*Second Preliminary Consultation*  
**MONTGOMERY COUNTY HISTORIC PRESERVATION COMMISSION**  
**STAFF REPORT**

<b>Address:</b>	7110 Sycamore Ave., Takoma Park	<b>Meeting Date:</b>	4/19/2017
<b>Resource:</b>	Contributing Resource (Takoma Park Historic District)	<b>Report Date:</b>	4/12/2017
<b>Applicant:</b>	Joan Marsh (Owen Philbin, Agent)	<b>Public Notice:</b>	4/5/2017
<b>Review:</b>	Second Preliminary Consultation	<b>Tax Credit:</b>	Partial
<b>Case Number:</b>	N/A	<b>Staff:</b>	Michael Kyne
<b>PROPOSAL:</b> Roof reconfiguration, non-historic window replacement, and other alterations

The applicant has revised their proposal in accordance with the Commission's comments and, per staff's suggestion, returned for a second preliminary consultation. Specifically, the applicant has made the following revisions:

PROPOSED FRONT (EAST) ELEVATION

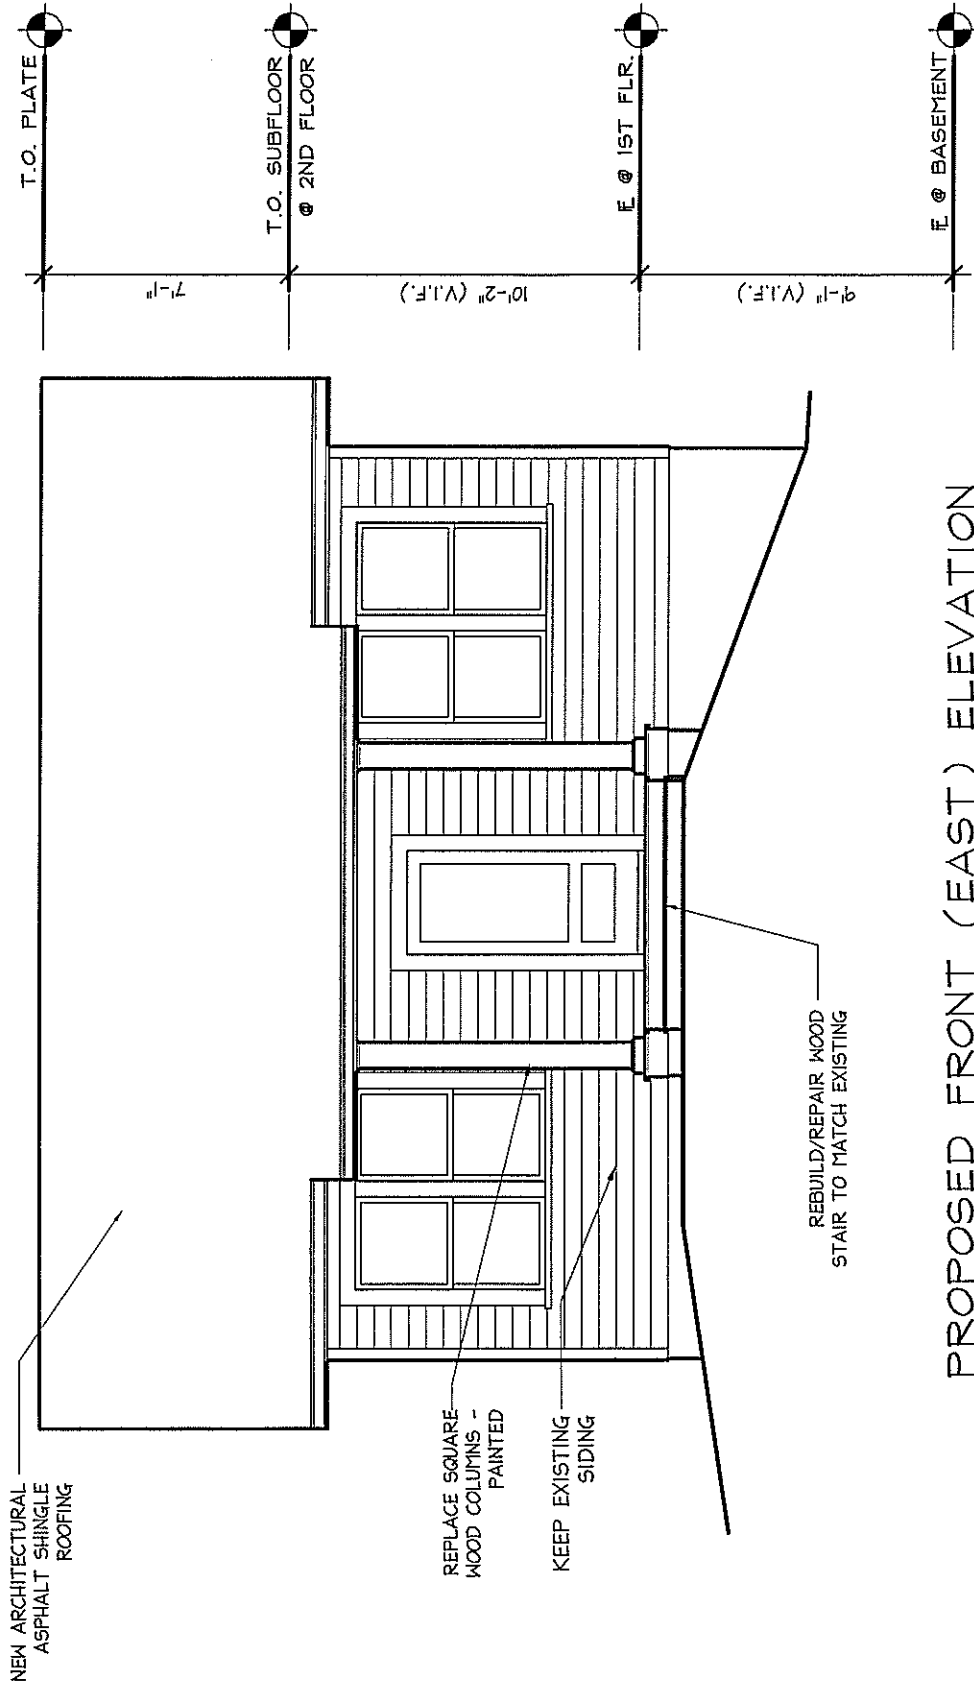
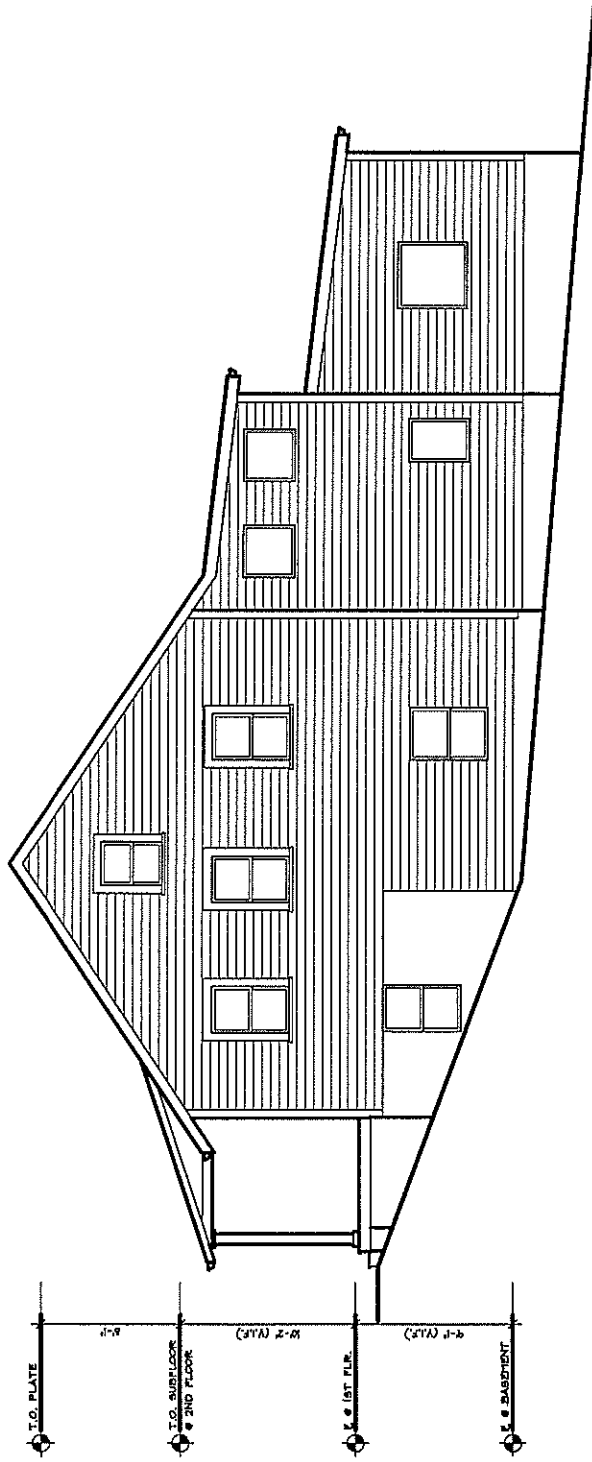
The applicant has indicated that the central front porch will be rebuilt, in accordance with the Commission's previous comments; however, the proposed front elevation for Option 1 depicts a wider central porch, and the proposed side elevations for both options depict a shallower front porch. In order to preserve the original front porch form, staff suggests that the central front porch be rebuilt with the same approximate dimensions and design. Staff asks for the Commission's guidance on this matter.

PROPOSED NORTH ELEVATION

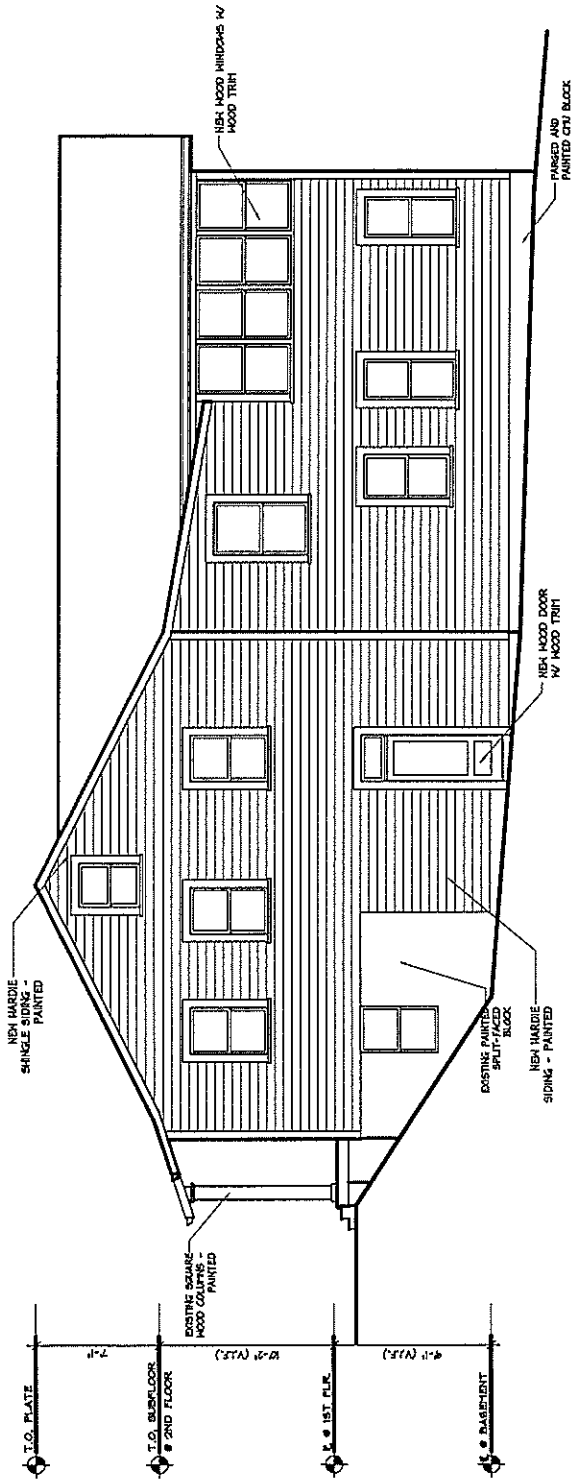
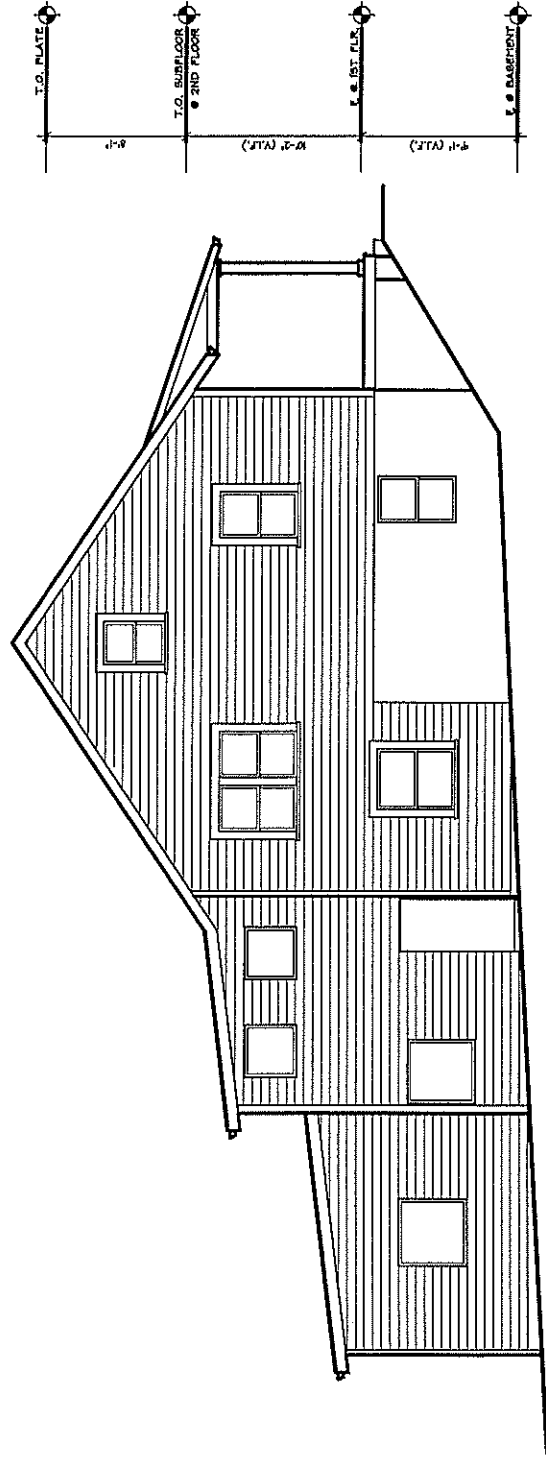
Although it is not depicted in the existing elevations, there is currently a wooden deck on the left side of the historic house. Per the left side elevations for Option 1, the applicant proposes to remove the existing deck and construct a new deck on the left side of the proposed new rear addition. At this time, the dimensions (and, specifically, the projection) of the proposed new deck have not been provided. Staff asks for the Commission's guidance regarding the appropriateness of the proposed new deck.

PREVIOUS PROPOSAL

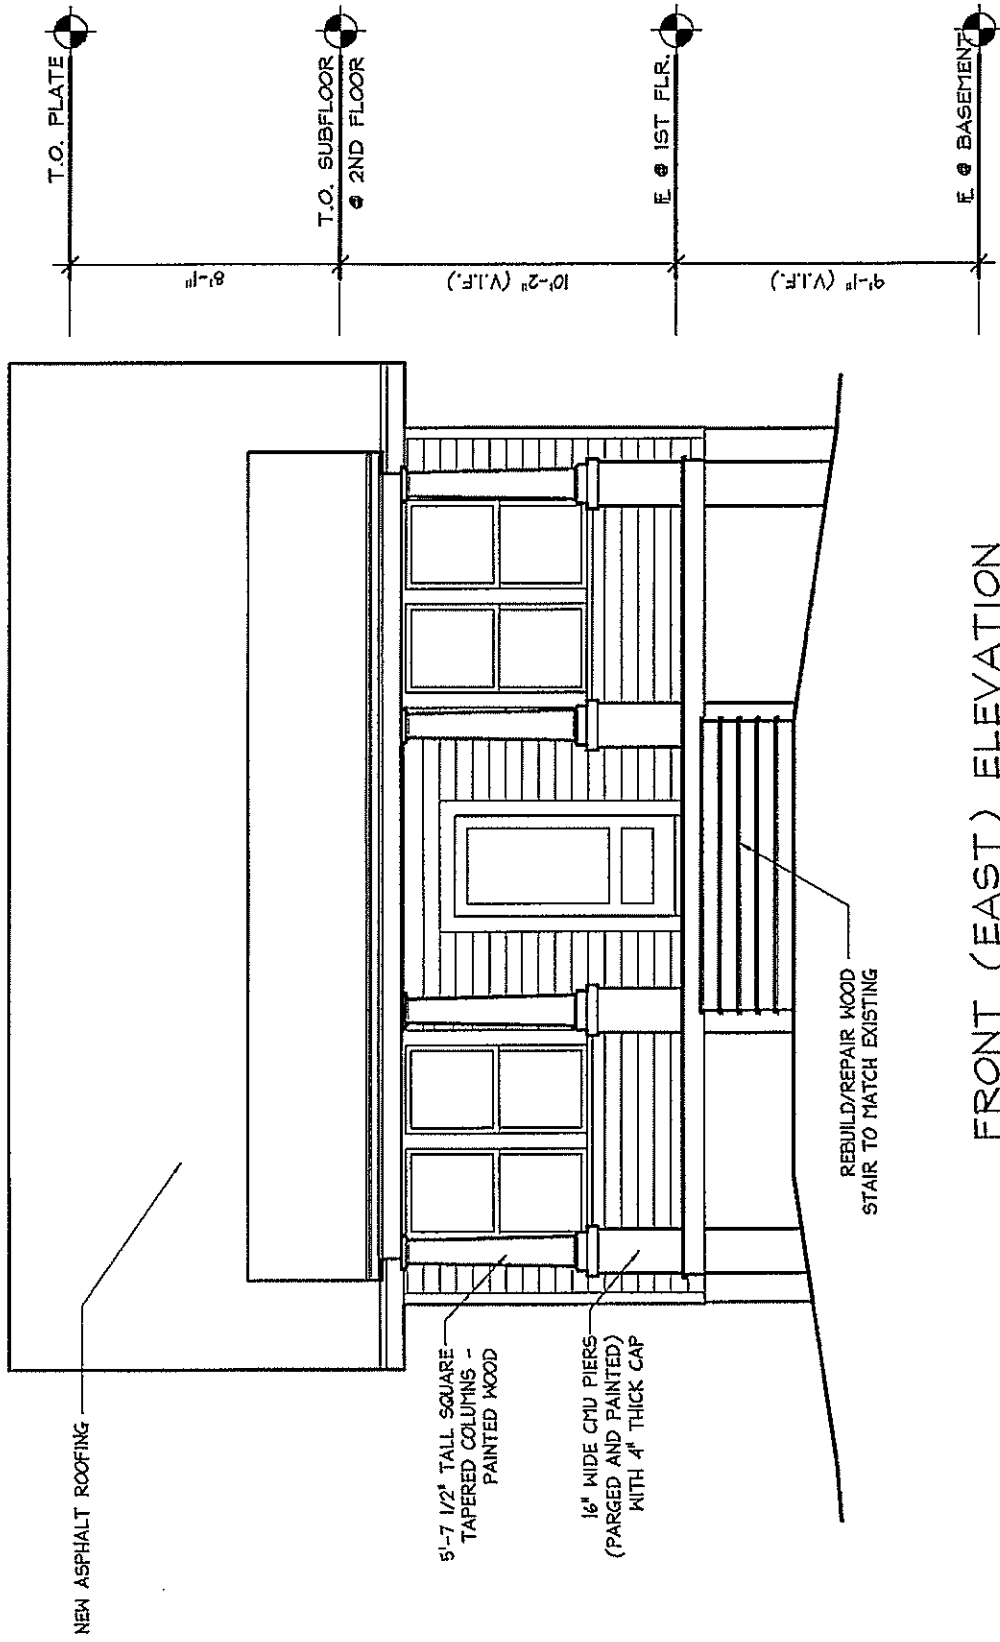
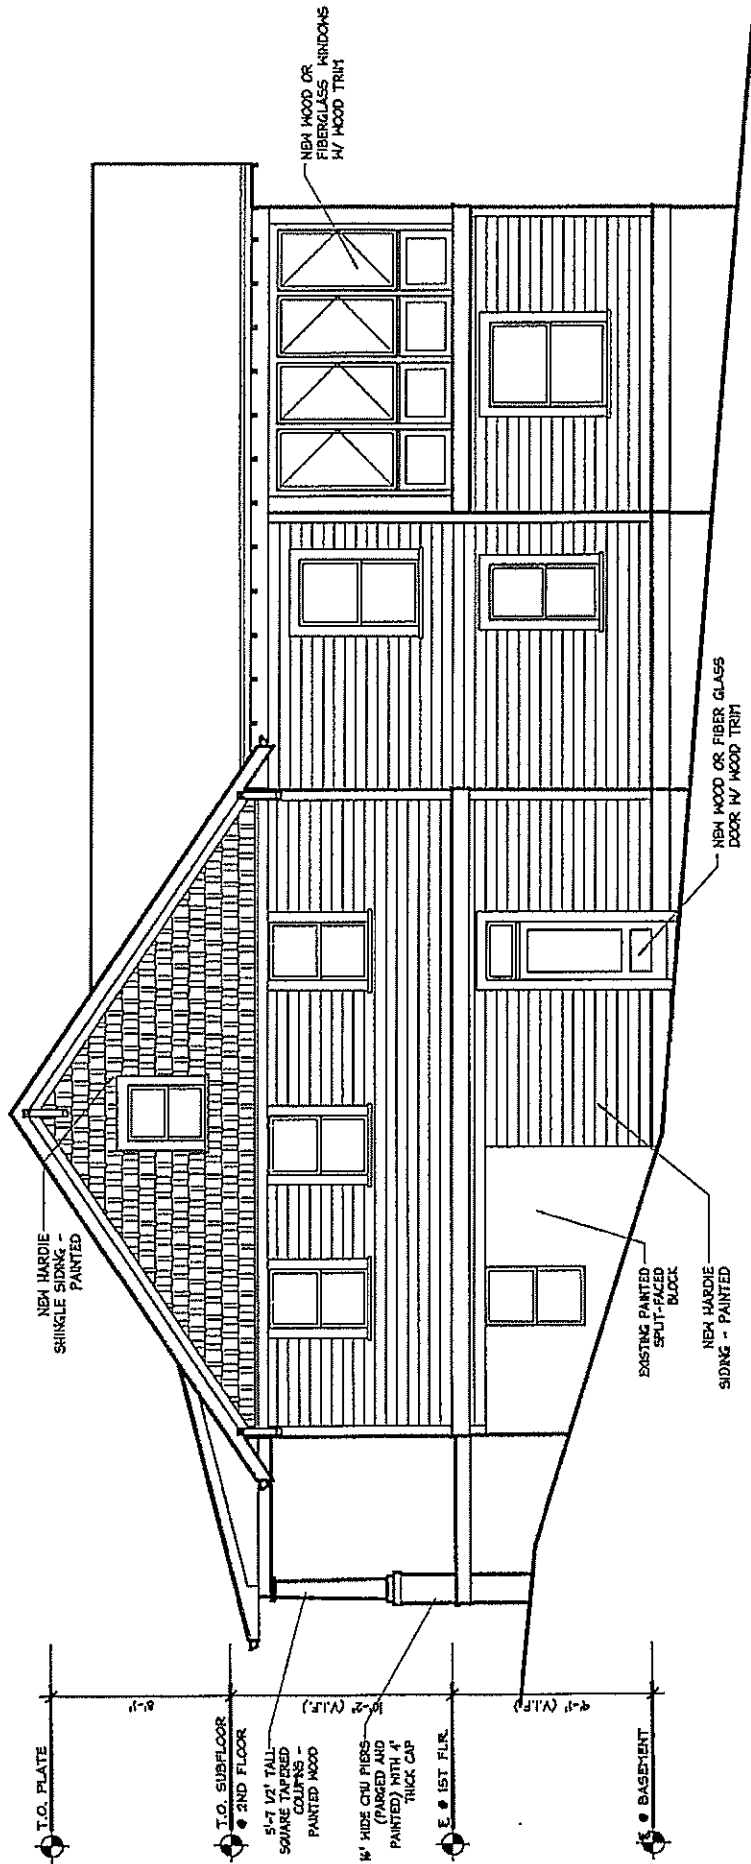
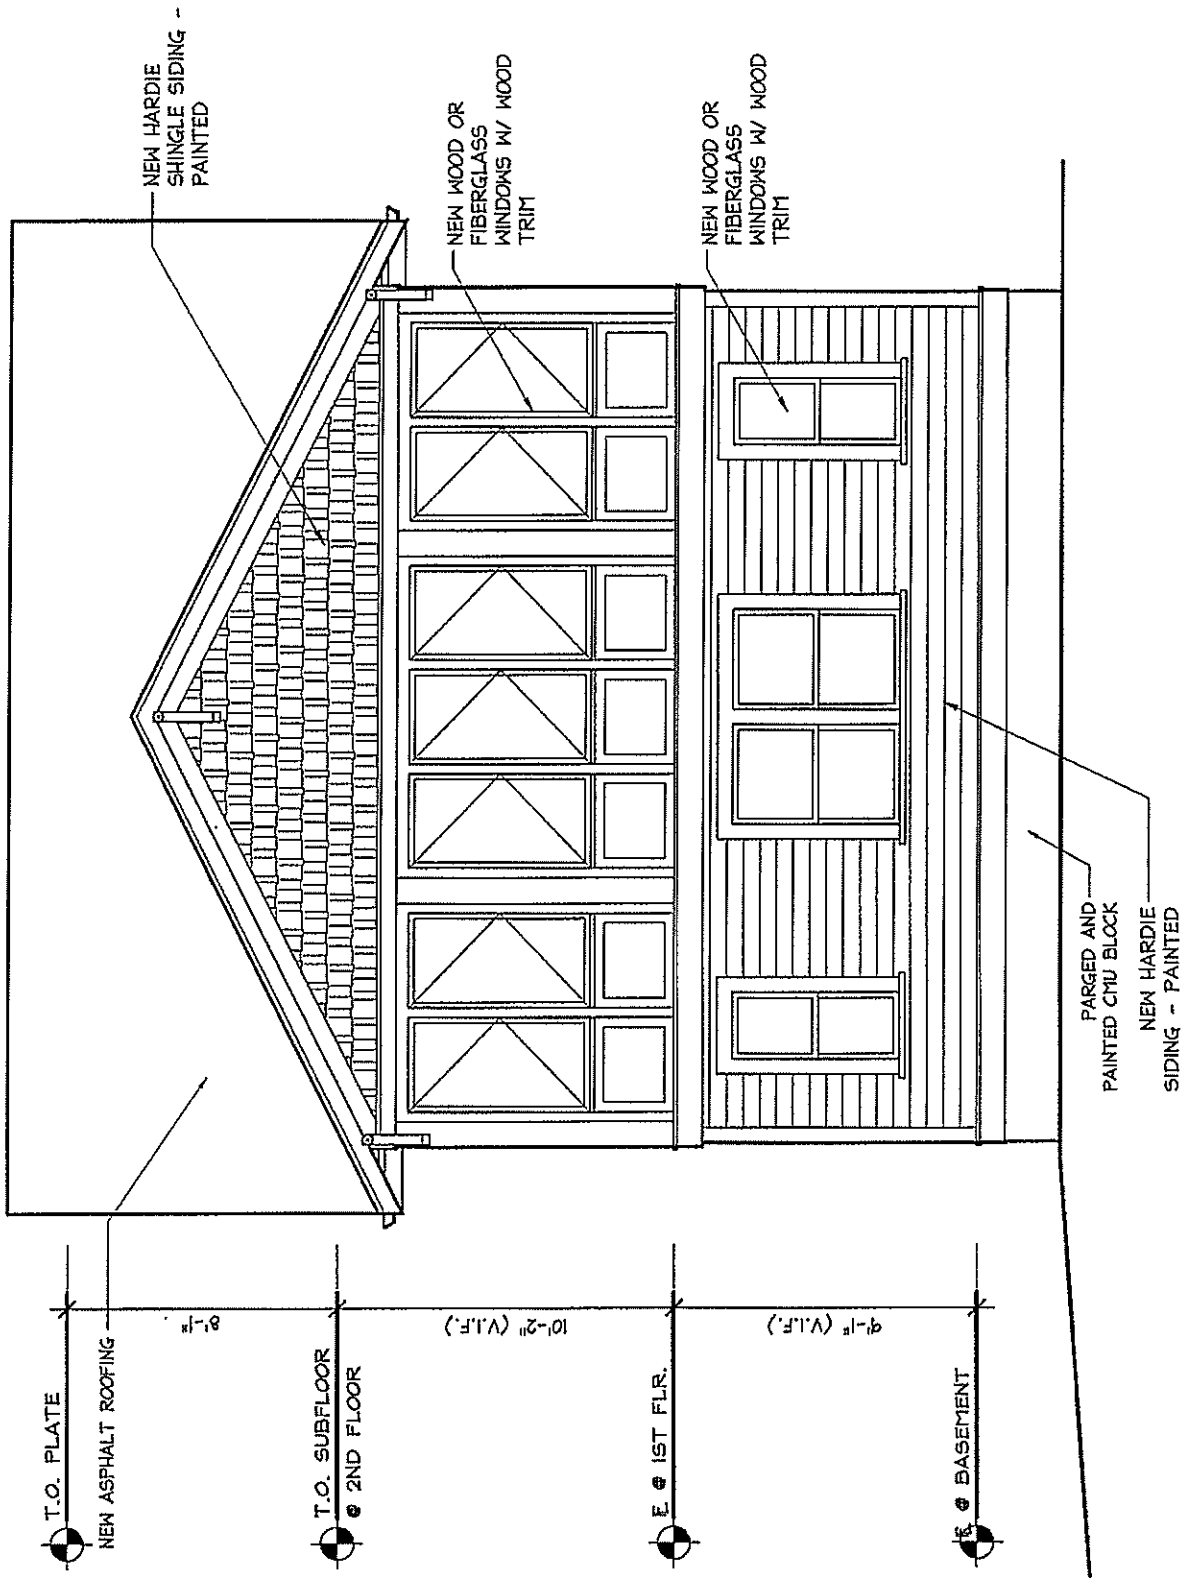
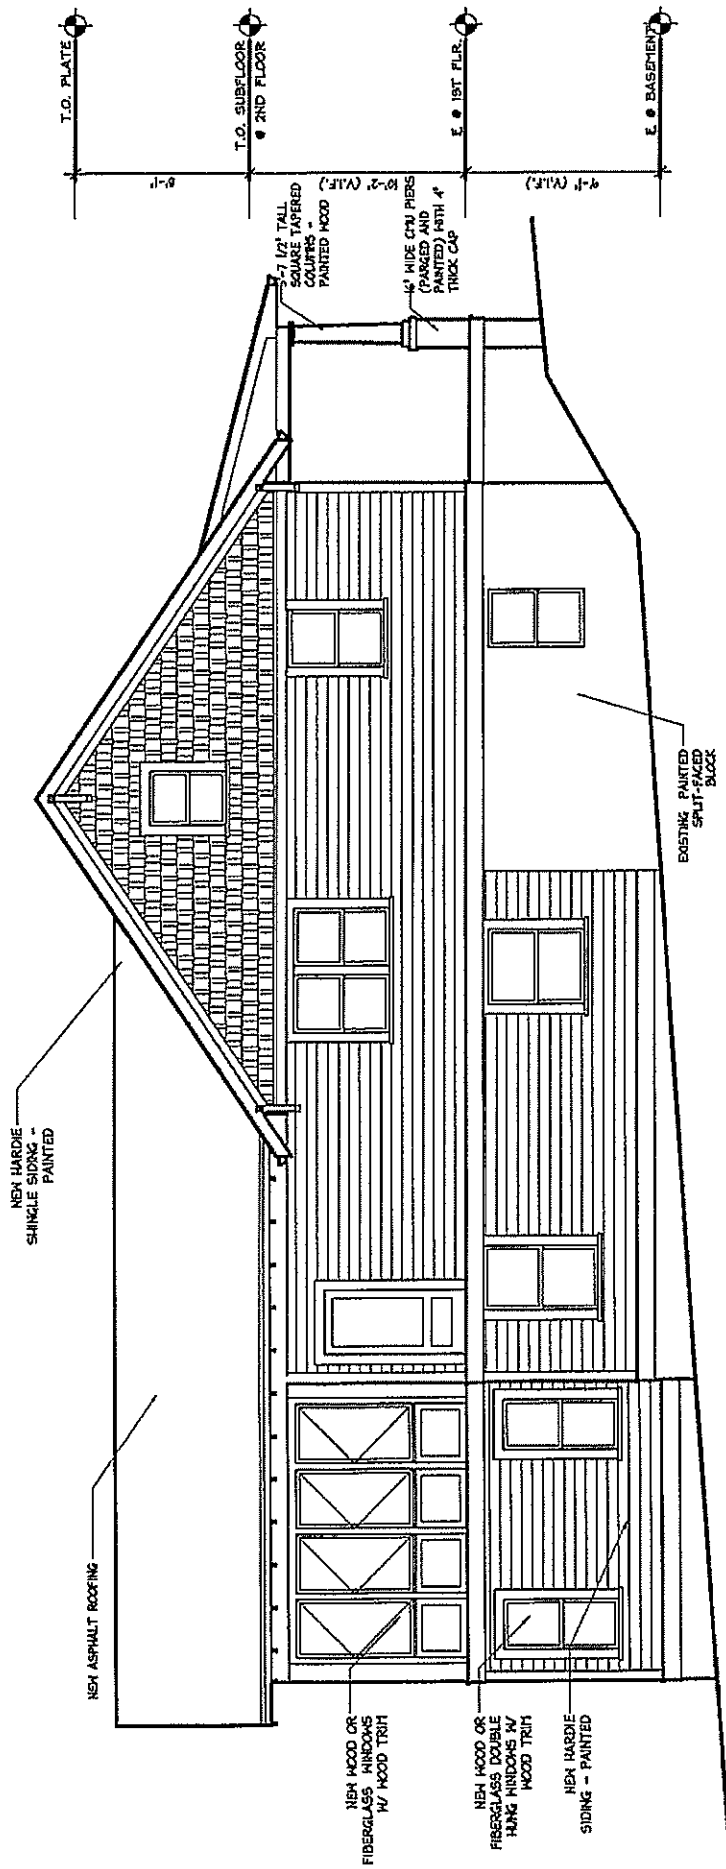
- The original siding appears to be in good condition and should not be removed/replaced.
- The 1927 Sanborn map indicates that the central front porch is original to the house and it should not be replaced with a full-width front porch.
- The design of the historic house is rather simple, and it would be inappropriate to add ornamentation (brackets, exposed rafter tails, band boards) to the historic house and/or rear addition.
- The windows in the proposed rear addition should be consistent in size.

There was some discussion about which sections of the existing house should be preserved and which can be removed. The Commission was unanimous in their finding that the rearmost addition (enclosed porch on stilts) is not historic and can be removed, while they were split as to whether the enclosed second-floor sleeping porch and section beneath (*referred to as Sections 2 and 3 in staff's presentation, see Circle 23*), which according to the 1927 Sanborn map are original to the house, should be removed.

- The existing siding will be retained on the historic house.

- The existing central front porch will be rebuilt (see staff's comments below).
- The previously proposed ornamentation has been removed.
- The windows in the proposed rear addition are consistent in size.
